M25 junction 10/A3 Wisley interchange

TR010030

8.3 Statement of Common Ground with Environment Agency

8.3 STATEMENT OF COMMON GROUND WITH ENVIRONMENT AGENCY

Figure A – River Restoration measures embedded into M25J10 design as of Feb 19 [not shared at meeting, but added to these minutes for information]

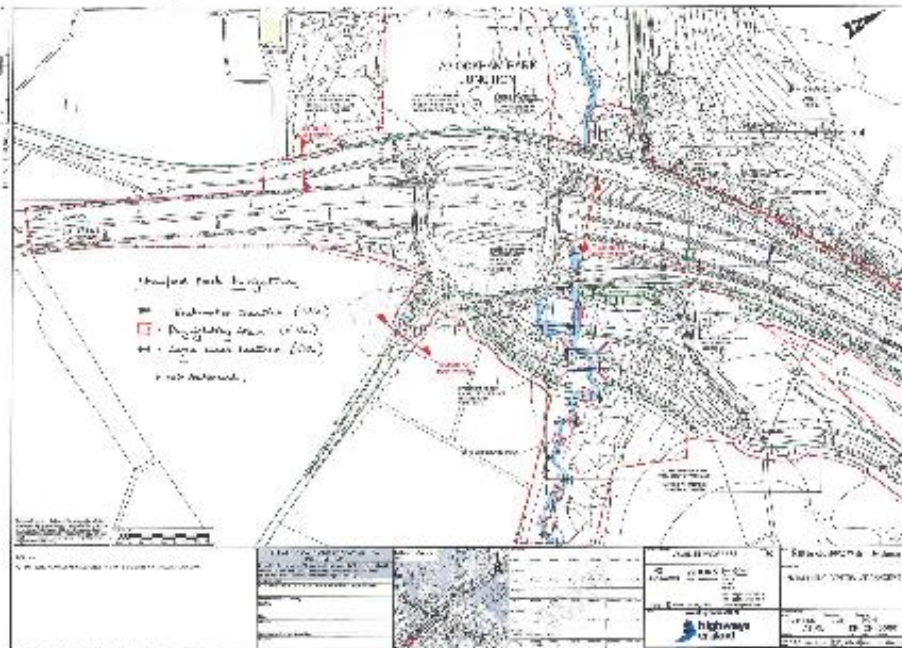
CG explained that in the notes from the meeting of 22.01.19 there are disagreements on what constitutes adequate mitigation for the river crossing. Atkins propose that the river restoration measures (set out in Figure A at the end of this document and provided for clarity but not presented at the meeting) are proportionate mitigation measures specifically targeted to ameliorate the effects
